ADDENDUM No. 01
DNR-220039
Delaware State Park Wastewater Treatment
March 14, 2024

Project: DNR-220039
Delaware State Park New Wastewater Treatment Facility
Ohio Department of Natural Resources
Hocking Hills State Park, Hocking County, Ohio

DELAWARE STATE PARK WASTEWATER TREATMENT PLANT IMPROVEMENTS
DNR-220039
DELAWARE COUNTY, OH

CONCRETE BOLLARD
NOT TO SCALE

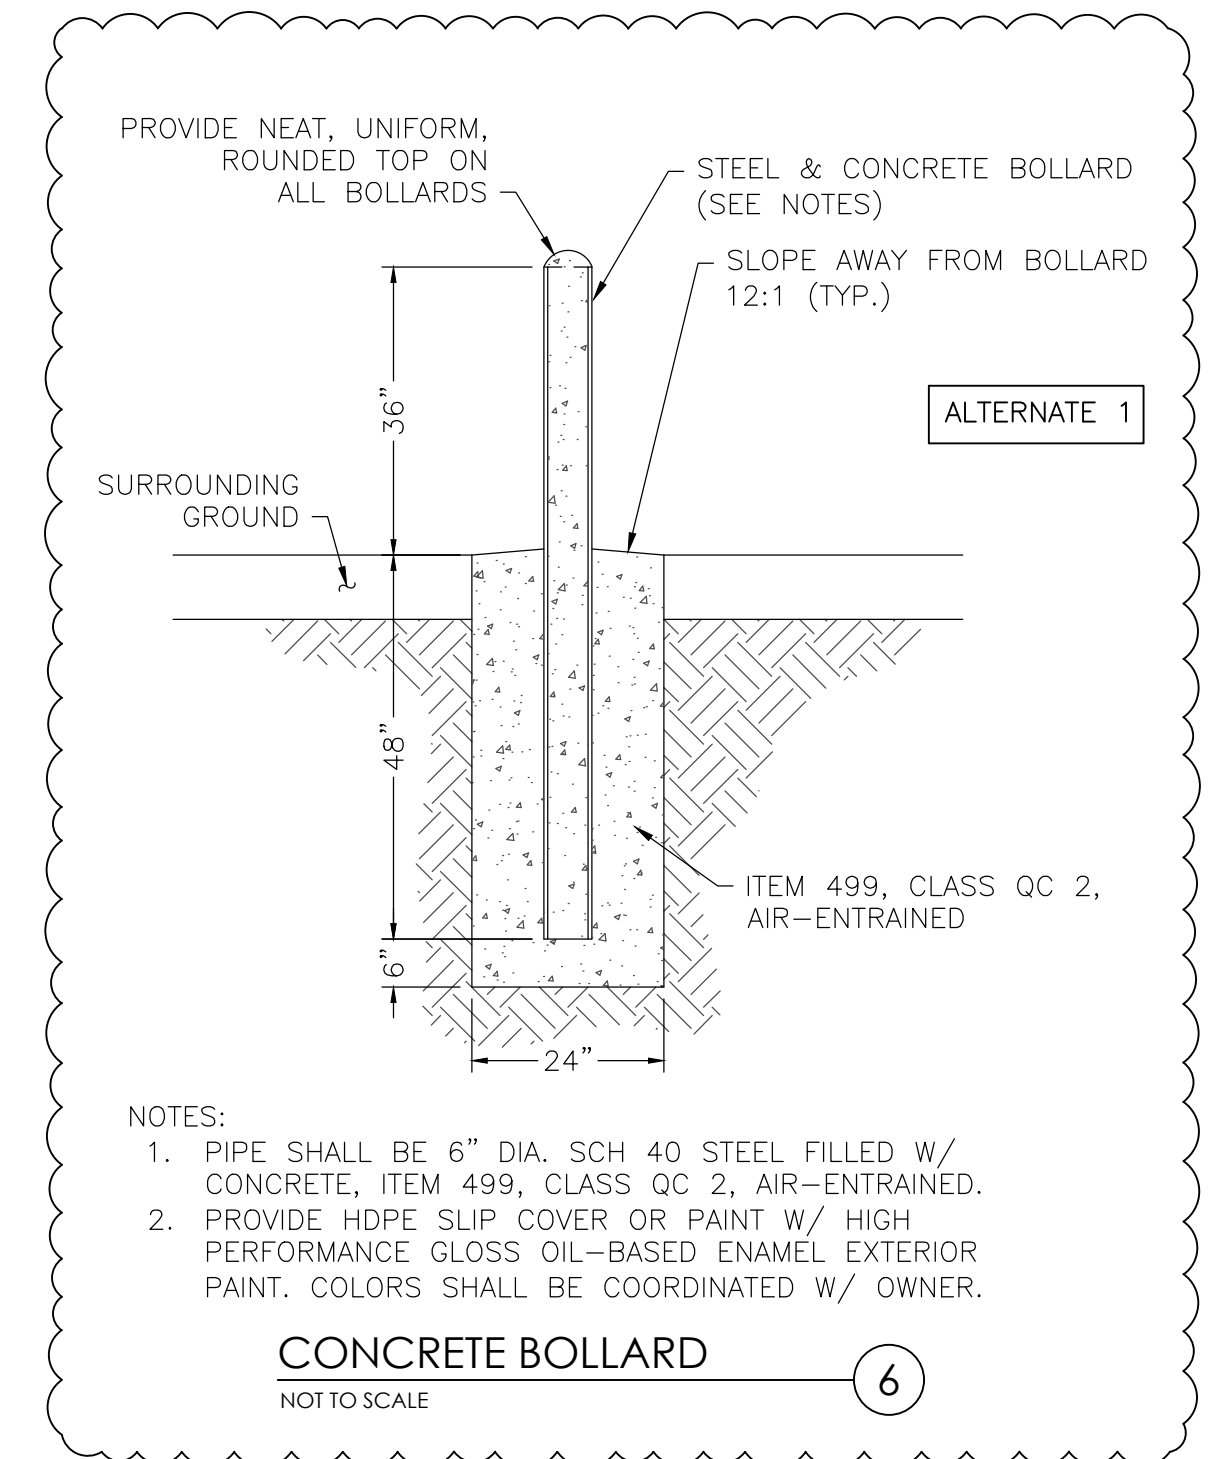
1. Title Sheet, C1: Addition of Alternate (ALT) Identification
2. Index Map, C2: Improved resolution for clarity
3. C3: Revised Bollard Detail – Identified as inclusion in ALT 1
4. C9: Revised elevation into Disk Filter
5. C11: Revised Plant Flow and Filter Flow data in chart
6. C15: Revised Disk Filter Model Number for Basis of Bid
7. C16: Revised Demo Keynotes
8. C17: Revised Site Keynote #13
9. C18: Revised profiles
10. C19: Revised to identify work as ALT 2
11. C21: Revised to identify ALT 2 and ALT 3 associated work

- NOTES:
- PIPE SHALL BE 6" DIA. SCH 40 STEEL FILLED W/ CONCRETE, ITEM 499, CLASS QC 2, AIR-ENTRAINED.
 - PROVIDE HDPE SLIP COVER OR PAINT W/ HIGH PERFORMANCE GLOSS OIL-BASED ENAMEL EXTERIOR PAINT. COLORS SHALL BE COORDINATED W/ OWNER.

SITE PLAN PHASE 2 - GRADING

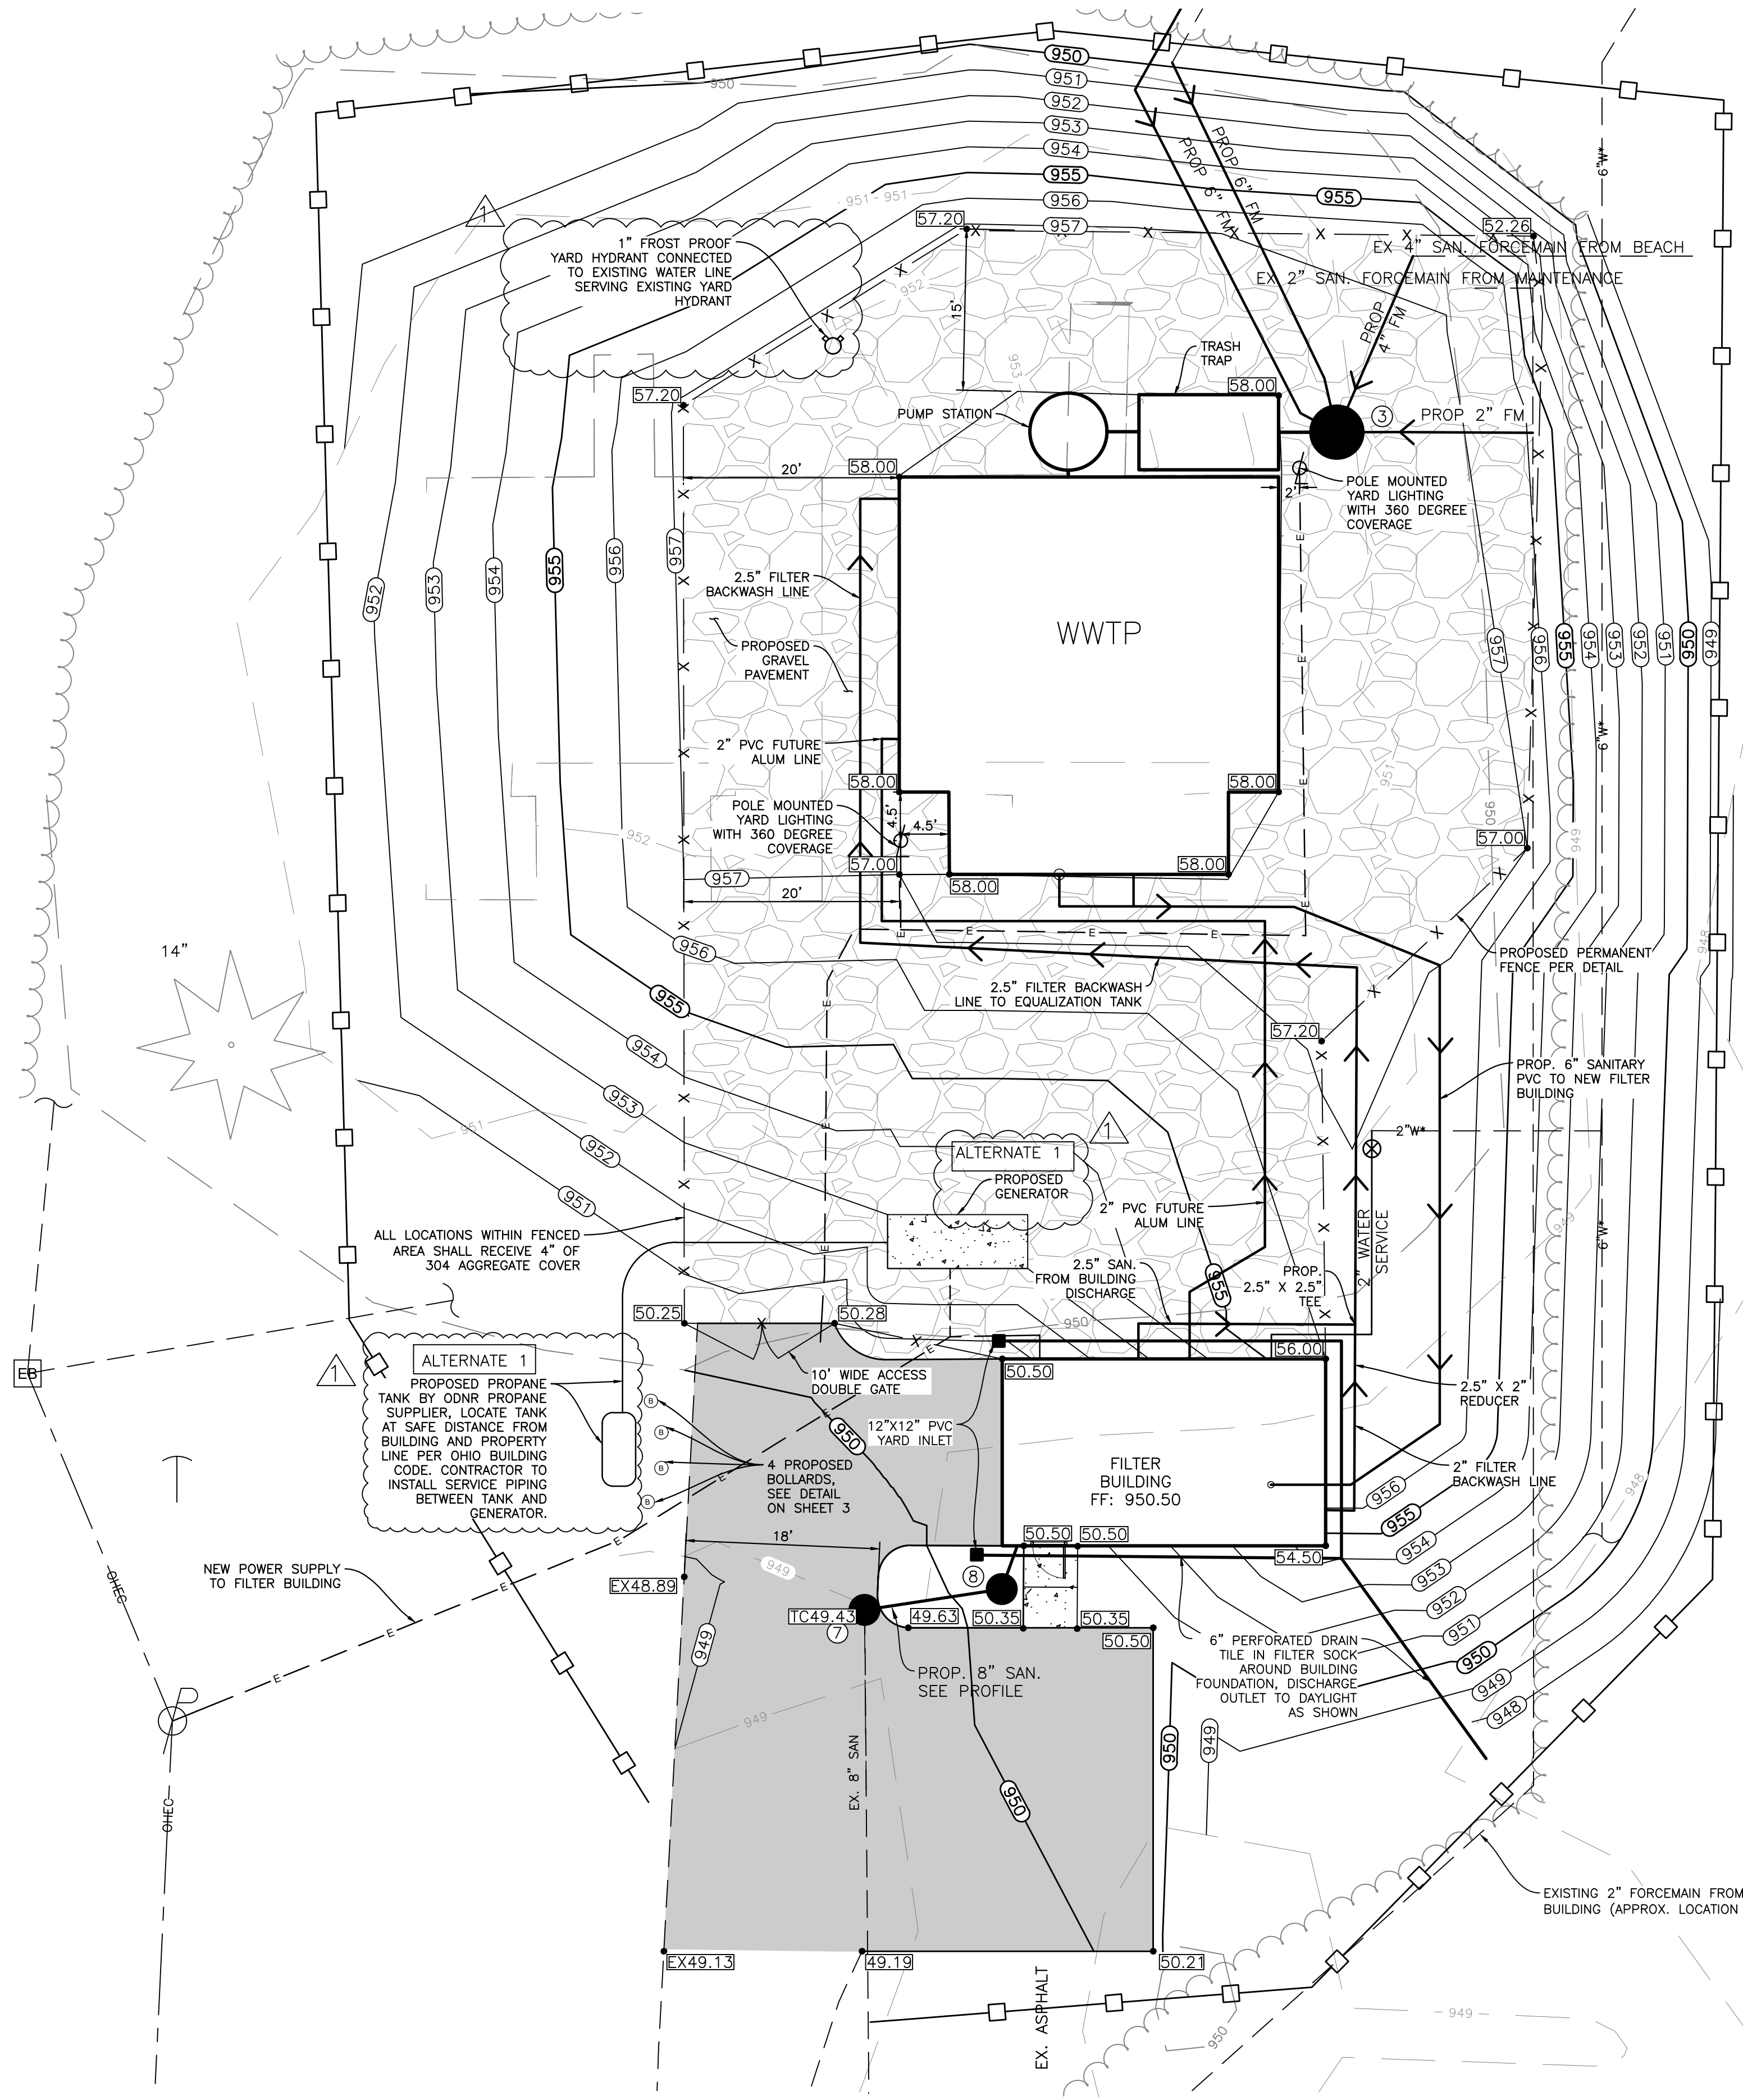
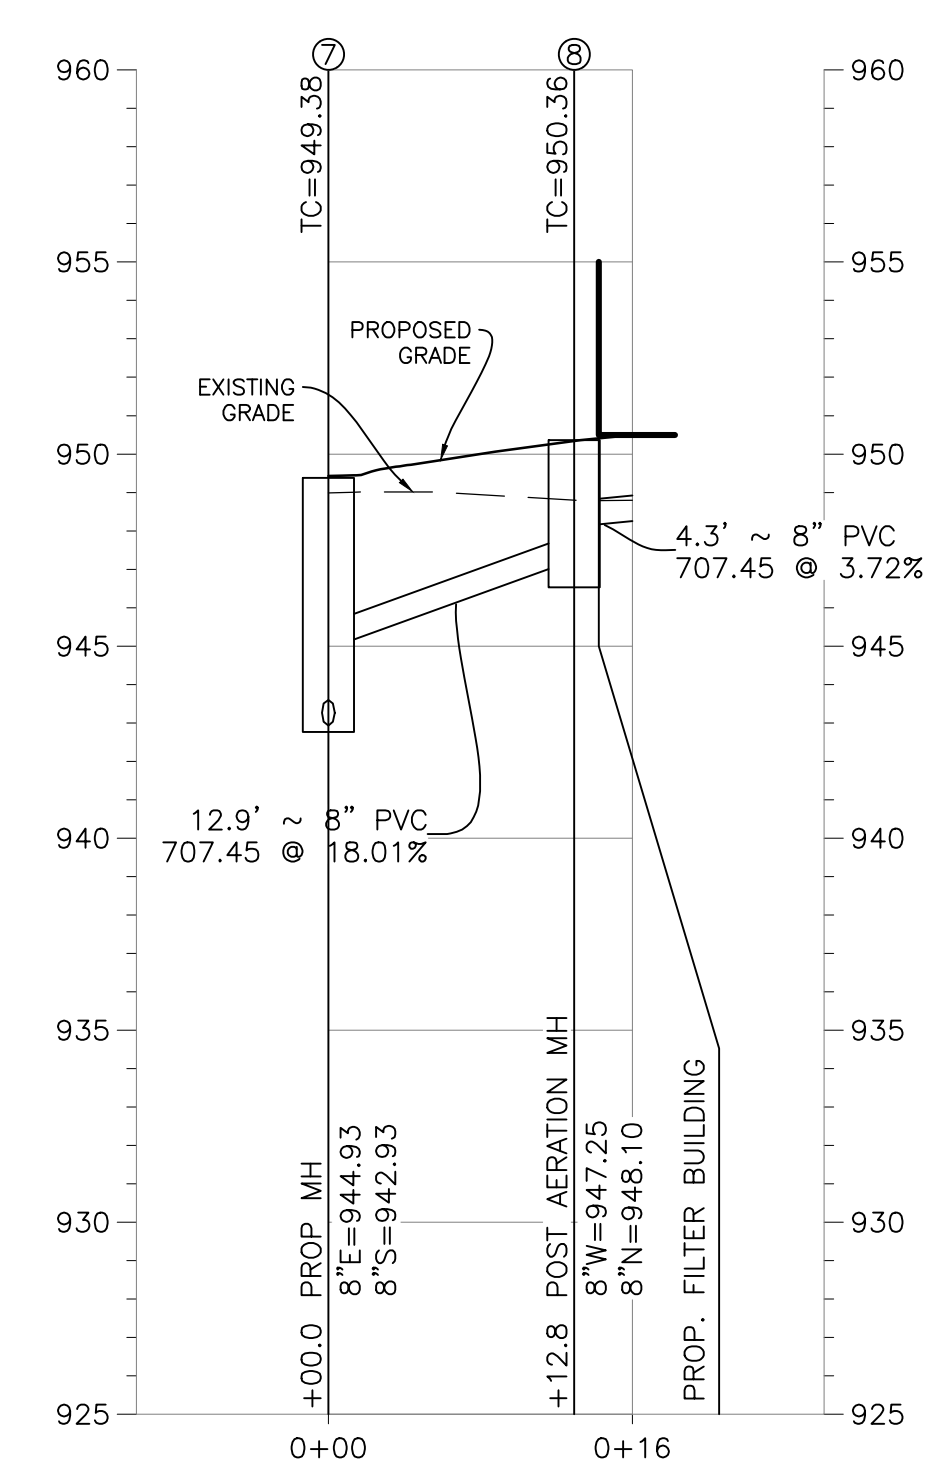
12. C22: Revised to identify power supply connection location and site surface aggregate addition of 2" #8 limestone. Revise propane tank bollard total from 2 to 4, and clarify work responsibility associated with propane tank and propane piping (associated with ALT 1)
13. C23: Revised note to read "Breakers and Staters" , not just "Breakers". Identify this sheet as inclusion with ALT2
14. E2: Revised electrical site plan

- PROPOSED CONTOUR & LABEL
- EXISTING CONTOUR & LABEL
- TRUNCATED SPOT GRADE MARKER
- TRUNCATED SPOT GRADE - MATCH EXISTING
- SANITARY STRUCTURE DESIGNATION
- SEDIMENT FENCE
- PROPOSED FENCE
- PROPOSED PAVEMENT SEE DETAIL ON SHEET C3
- PROPOSED 4" ~ 304 AGGREGATE TOPPED WITH 2" OF #8 LIMESTONE
